Project
11 View Road, N6 4DJ

Drawing Title
South-West Side Elevation Comparison

Project Number	Drawing Number	Revision
20055	PL-00-323	A

Rev A
Conservation Officer comments incorporated:

Decorative tile courses

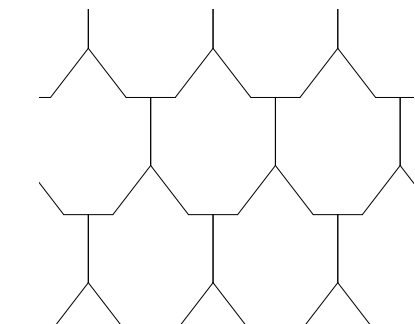
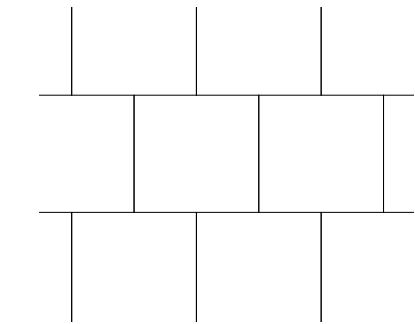
4. Decorative tile band (5 courses of decorative tiles) indicated thus. Each band of decorative tiles alternates with a similar height band of standard tiles.

See thumbnail for tile shapes.
